Addendum No. 2
Solicitation 25-99717
Railroad Street Reconditioning

This addendum serves to notify all bidders of the following changes to the solicitation documents:

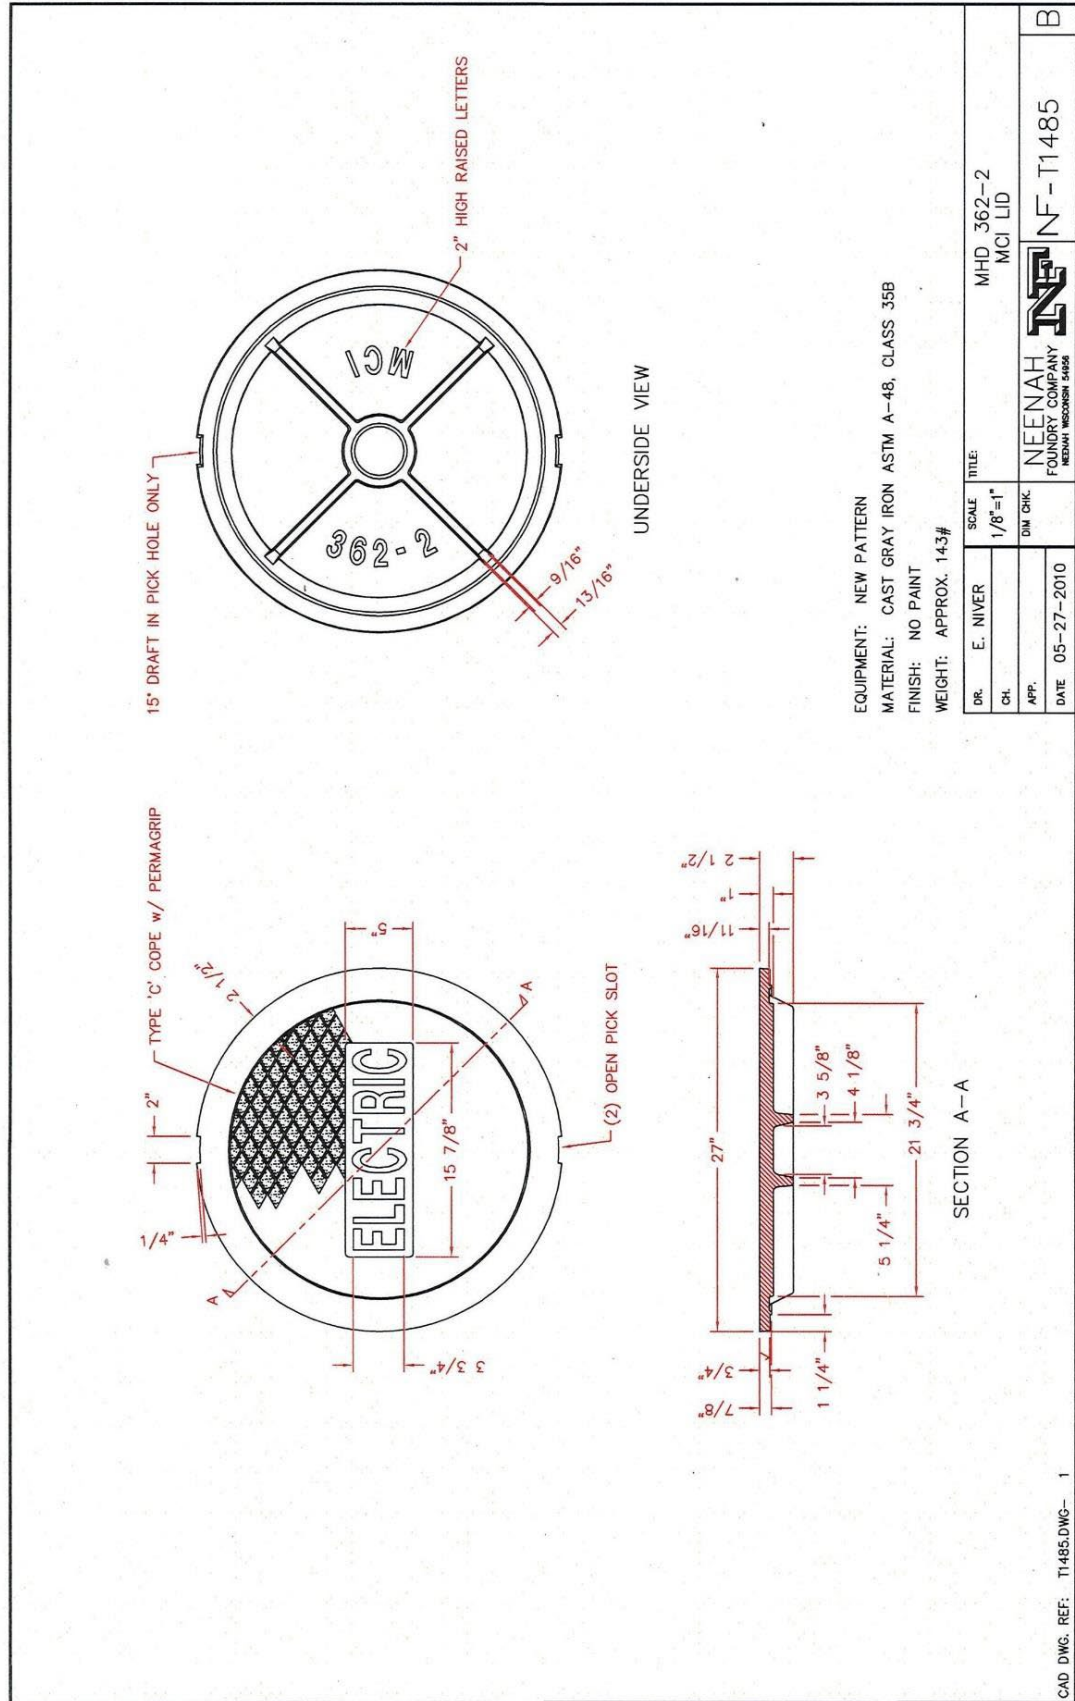
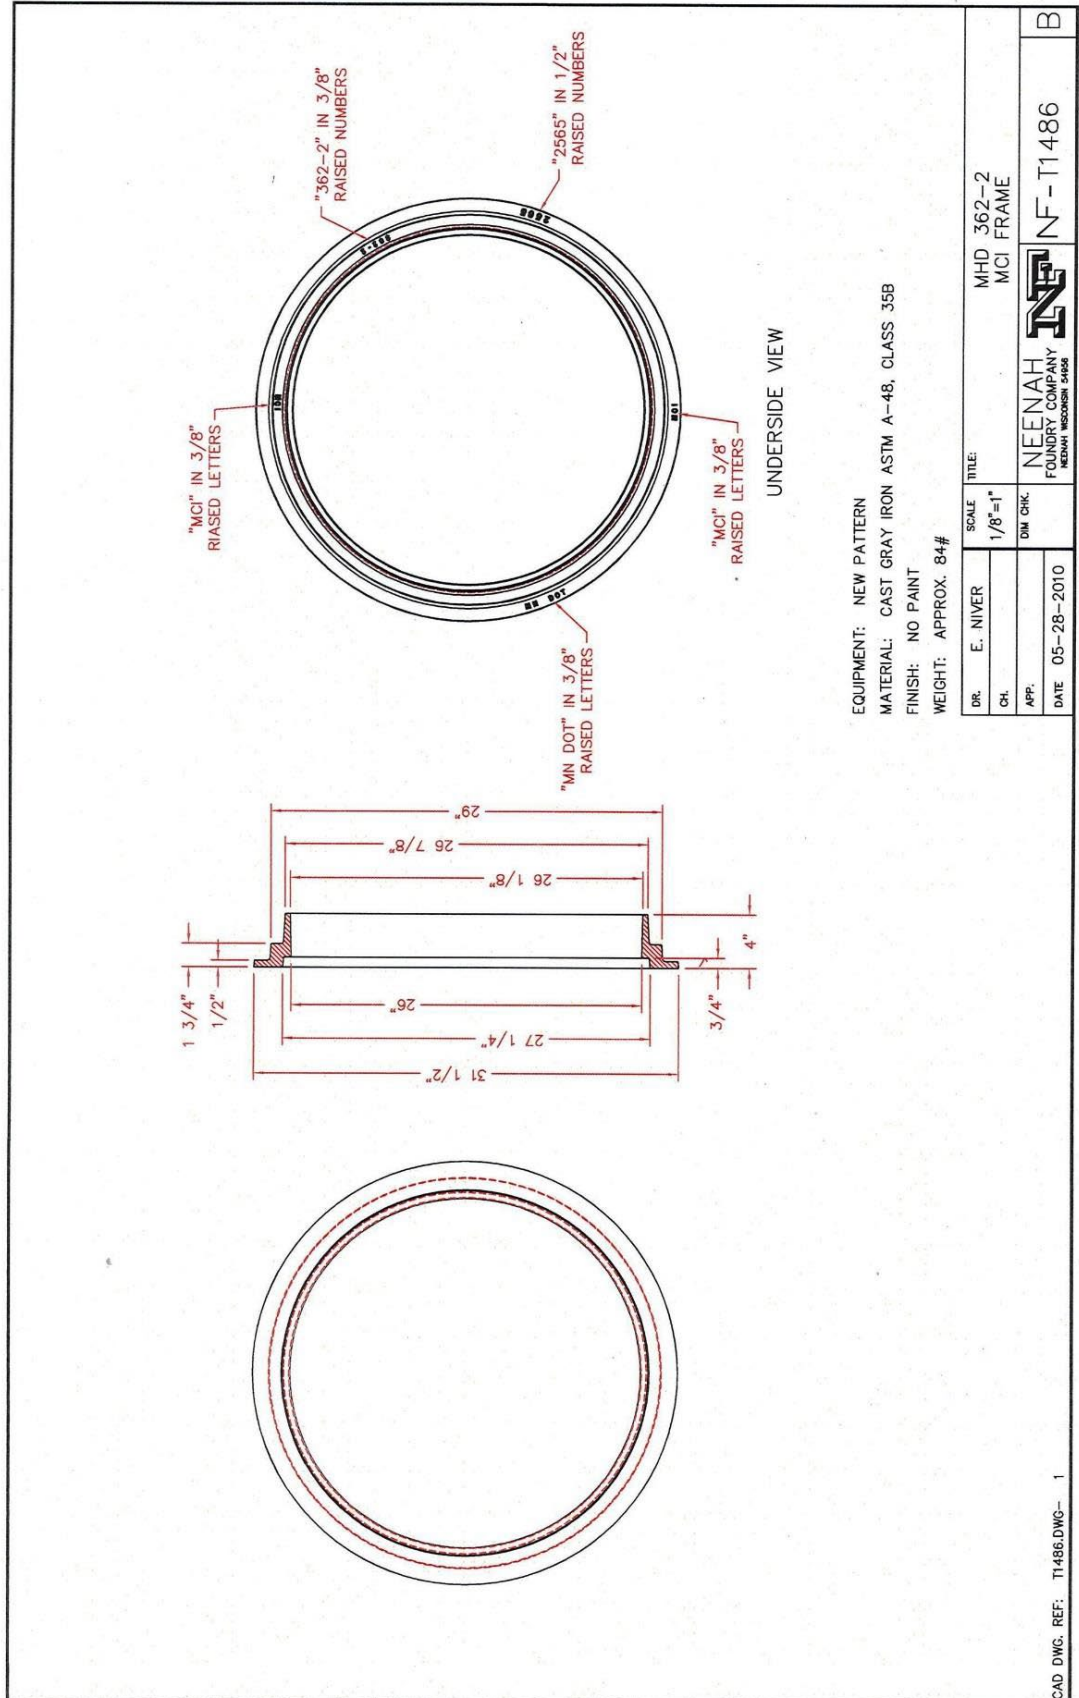
All handholes shall be PVC with modified metal frames and covers.

Emboss "**ELECTRIC**" on the cover for new traffic signal control handholes.

The frame and casting cover for all handholes shall be modified according to the following drawings:
